Inner Sydney high school
Response to Submissions - Architecture
NSW Department of Education

fjmt studio architecture interiors urban landscape community
04 October, 2017 - Document ref - Rev 01

3.0 Response to Submissions

Diagram 2c Distant views from Prince Alfred Park

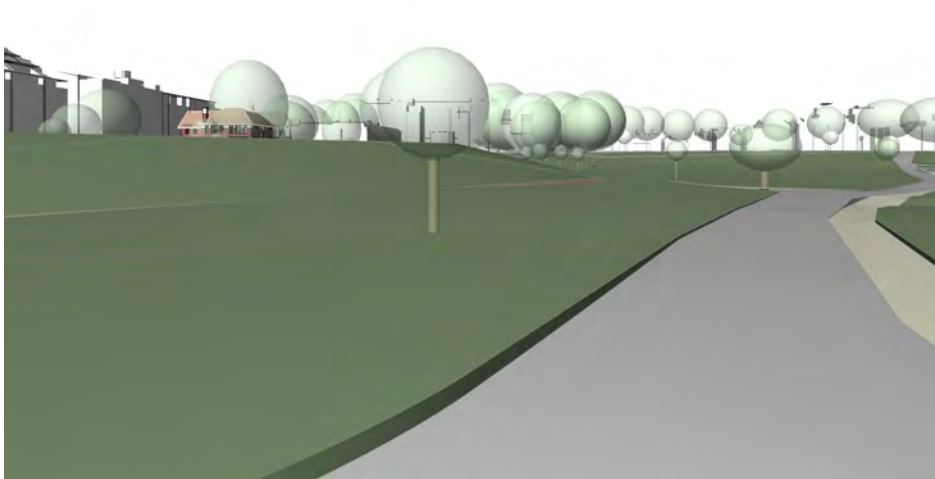
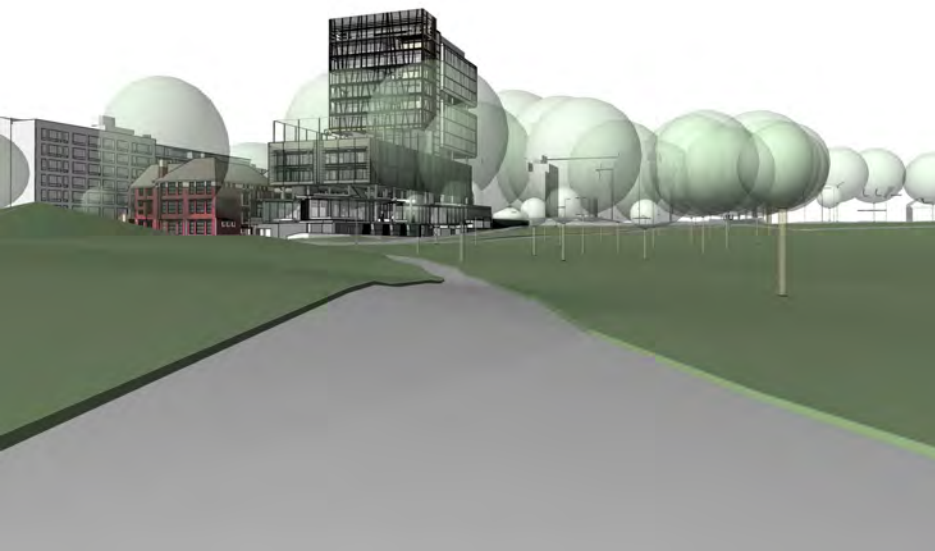
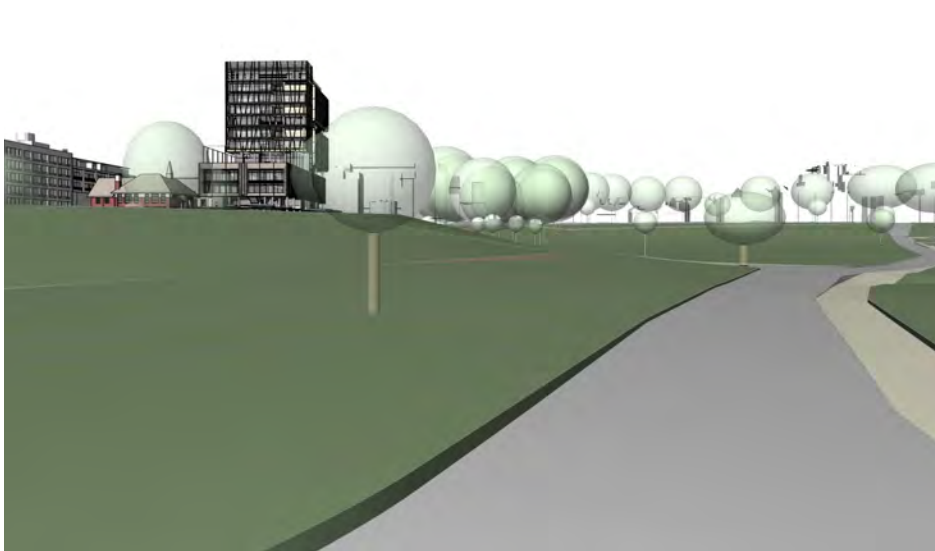
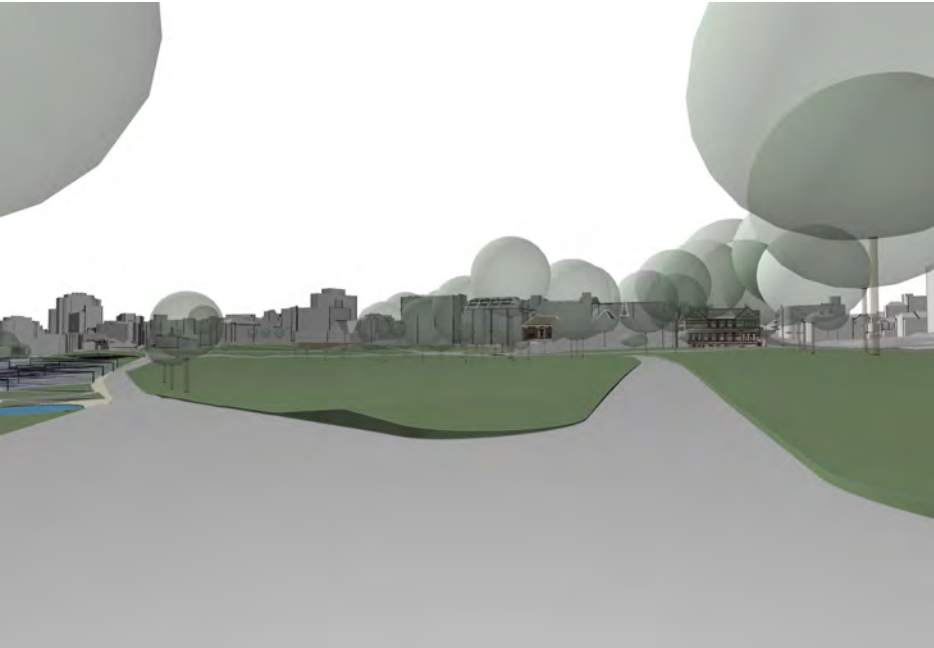
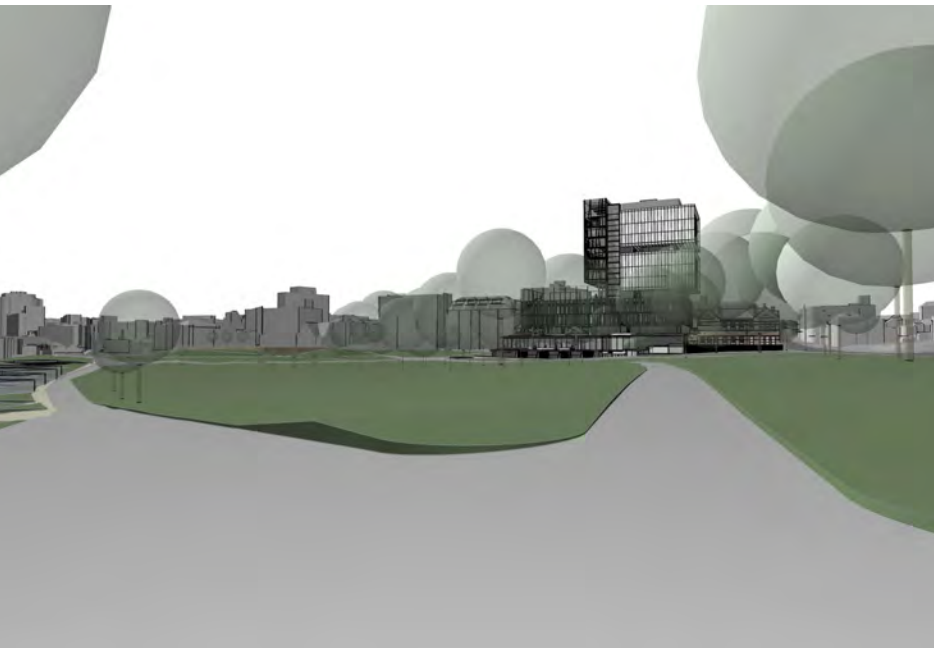
The proposal should include a visual impact assessment from key view points within the adjoining public open space

A number of views have been reviewed from major pathway junctions in Prince Alfred Park.

The topography of the park gently slopes up towards the new campus, which enables the dynamic forms to create a visual point of interest at the end of the vista.

The scale of the tower form sits against a foreground of the substantial avenue of trees to the south of the park

The impact of the new campus forms as viewed from the south/west corner of the park, a major accessway from Cleveland Street, is appropriately scaled in relation to the large fig trees and the scale of the warehouse buildings along Chalmers Street.

Diagram 3a i View from Chalmers Street of new Forecourt Entrance

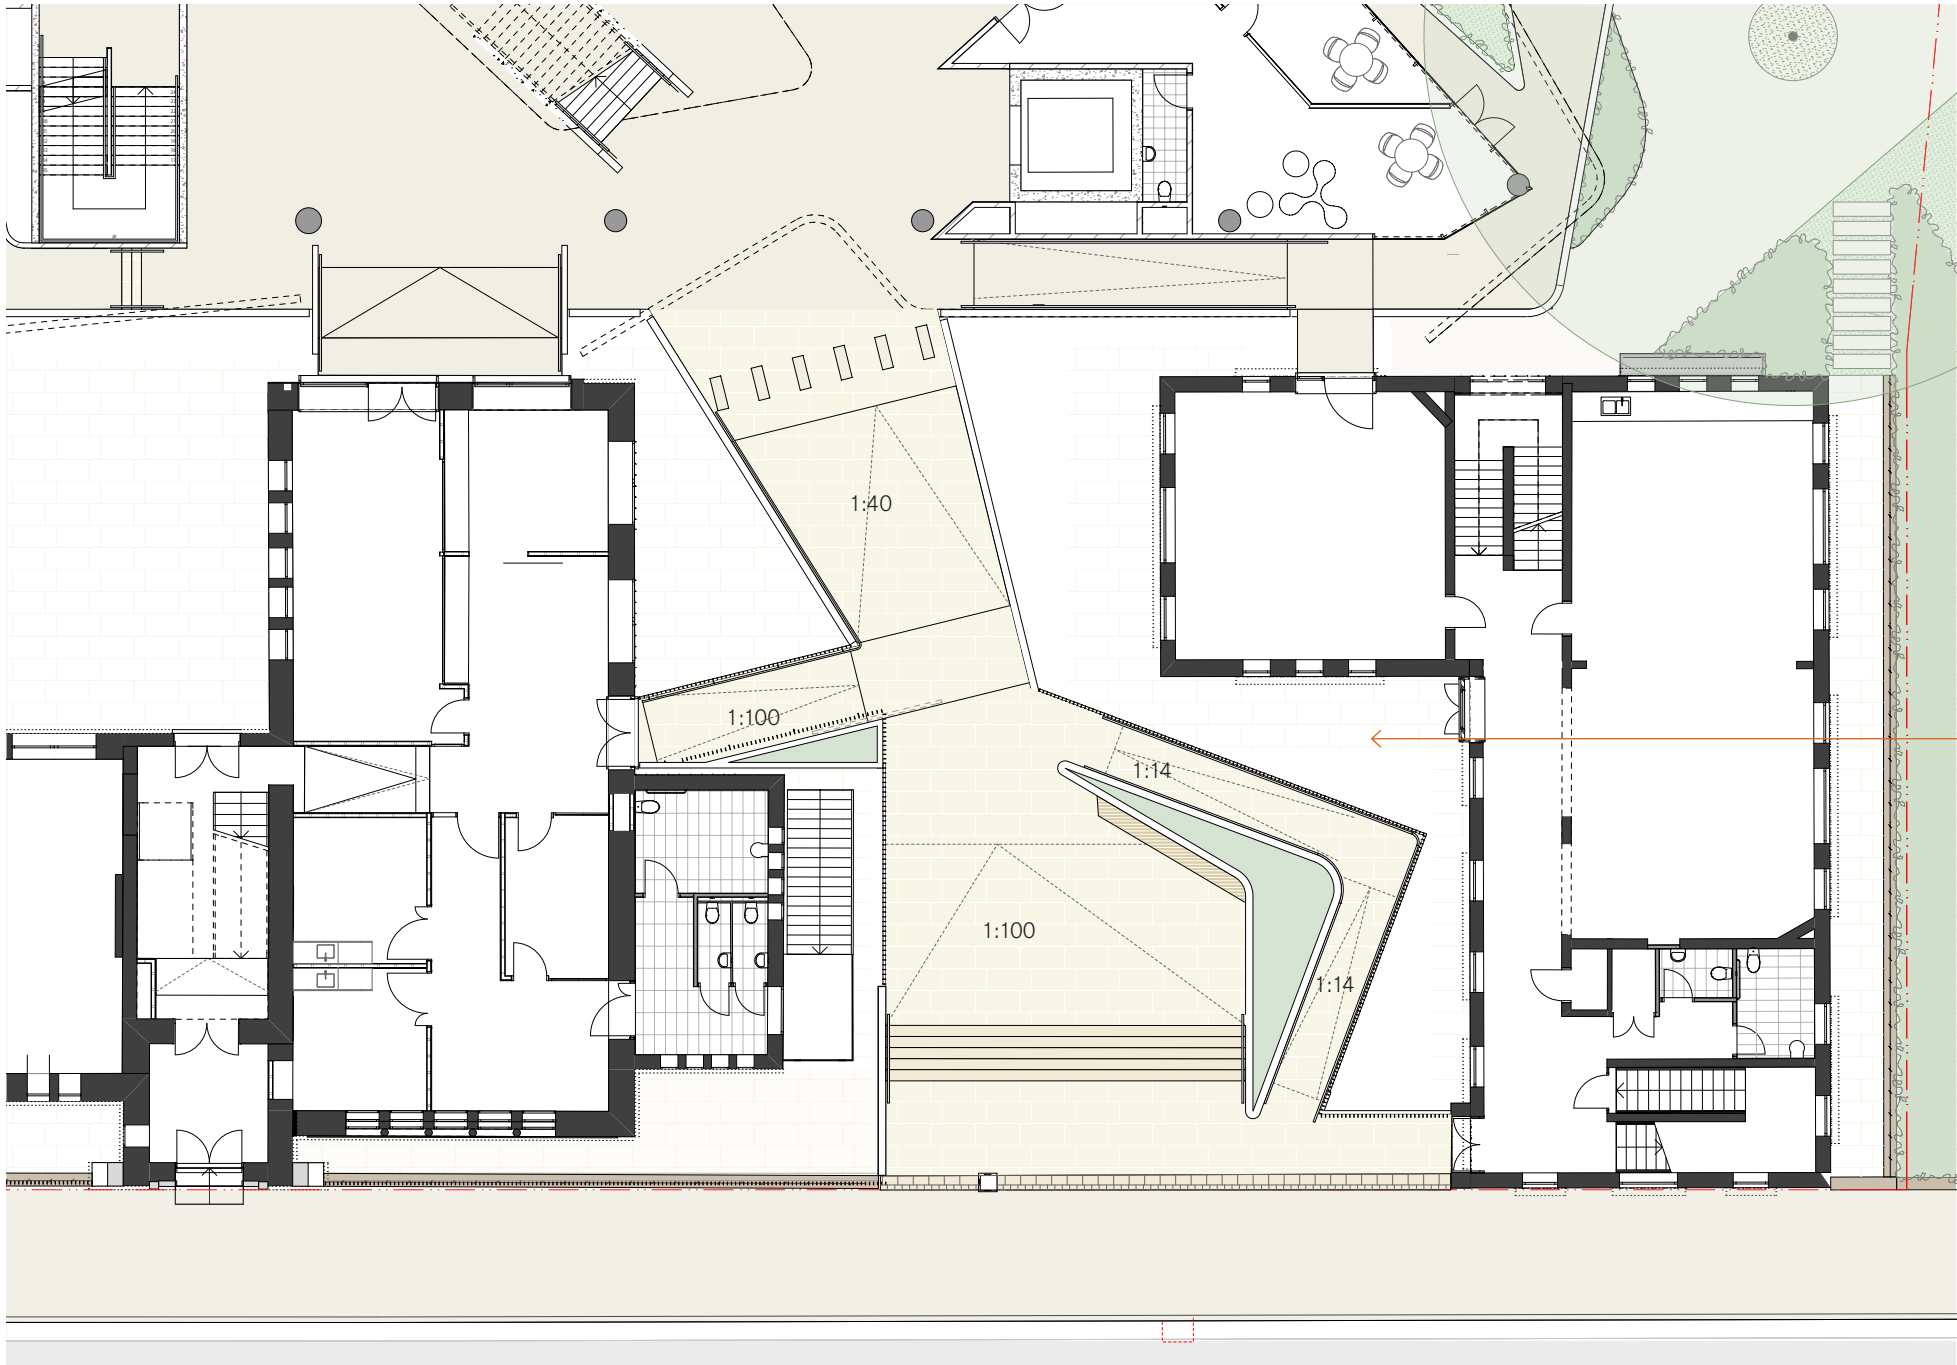
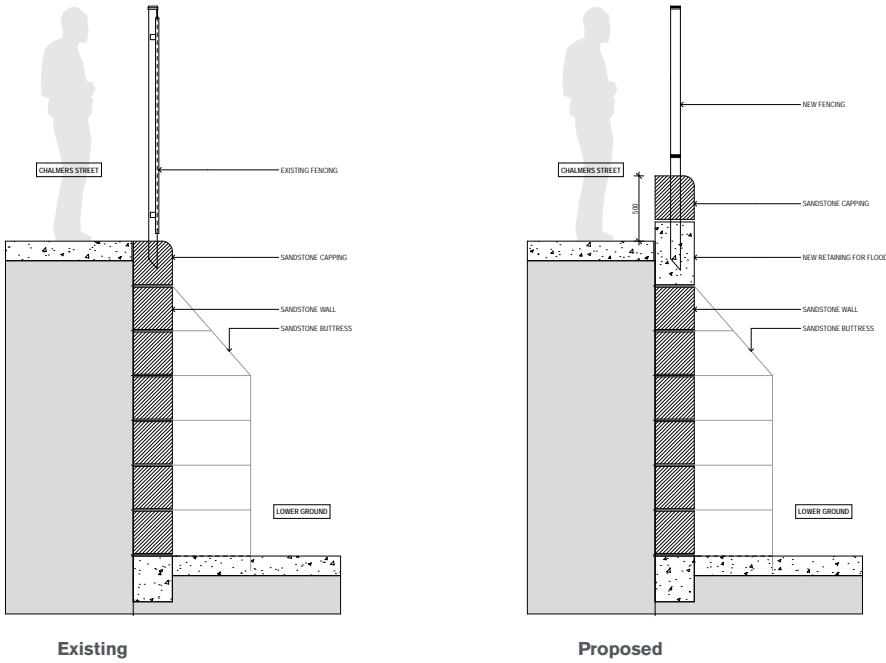
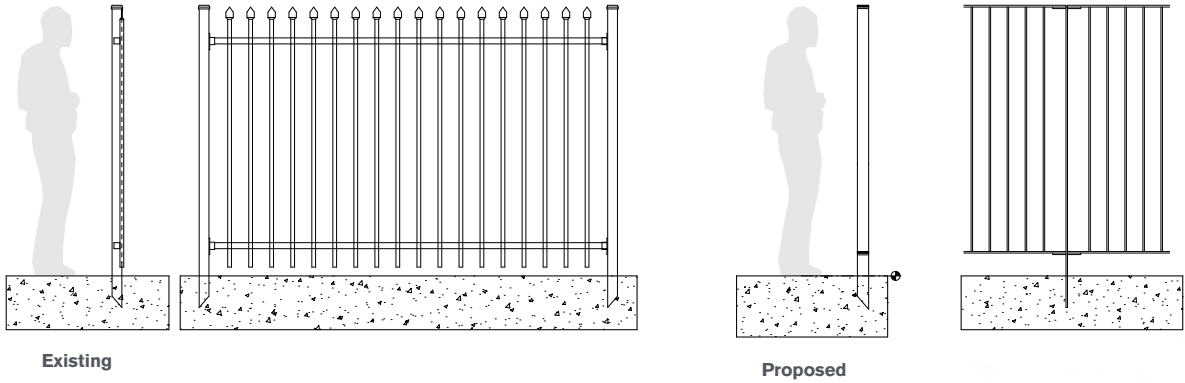
3	Reuse and alteration to existing heritage school buildings/grounds	
3a	The proposal also involves removal of the bridge walkways linking the buildings. Those links were made at later dates and are considered detracting to the significance of the historic school. The construction of the new building provide an opportunity to overhaul and reorganise the circulation of the campus. A new entry will be made on Chalmers Street between Building 3 and 2. The new entry will affect the North-eastern Courtyard which is identified of high significance by the CMP. Some rooms are proposed under the new entry, walk-way and planters. The south-facing windows at the lower-ground level are affected. The main entry on Chalmers Street is supported, as it follows the original design concept of the school and is consistent with council's DCP Local Character Statement. However, the lower level rooms are considered to have adverse impact on the intactness of the courtyard and integrity of Building C. The entry and walkway should be constructed in a reversible manner and the courtyard be largely retained.	<p>The design of the new entrance forecourt has been revised to provide a greater separation between Buildings 2 and 3. The forecourt geometry is realigned to response to the geometry of the new landscaped terraces providing a clear delineation between the old and the new. The levels to the forecourt have also been simplified and widened to cater for the student numbers. The educational model for the project is based on a staggered start, which reduces the number of students entering and exiting the campus.</p> <p>The learning spaces located under the forecourt within the existing courtyard have been reduced in scale to provide an improved amenity with increased access to daylight.</p> <p>Refer Ground Level Layout Plan 2003 and Lower Ground Level Layout Plan 2002</p>

A: 220661_City of Sydney Submission_2017Aug17_1223	
3b	The openings left by the removal of the bridge walkways are proposed to be retained and glazed. This is not supported. As the heritage buildings are highly intact except those later interventions and the facade containing those openings are highly visible from the streets, the original openings and joinery should be reinstated.	The openings left after the removal of the walkway will be expressed as new insertions into the existing fabric. As this site has always been a school, it is important that the layering of the site is understood. The design response will be a similar approach to the new openings developed by fjmt for the Mint on Macquarie Street for Sydney Living Museums. Refer Image 3b
3c	Existing palisade fence on the southern boundary is not highlighted in the plans and HIS report. The fence is the remnant of the old fence of Prince Alfred Park. It is to be retained and incorporated in the design.	The existing palisade fence on the southern boundary will be retained. A new 500mm high flood mitigation wall will be located to the inside face of the fence plinth.

New boundary fence with flood mitigation wall. Existing sandstone plinth maintained.

New fence to forecourt boundary
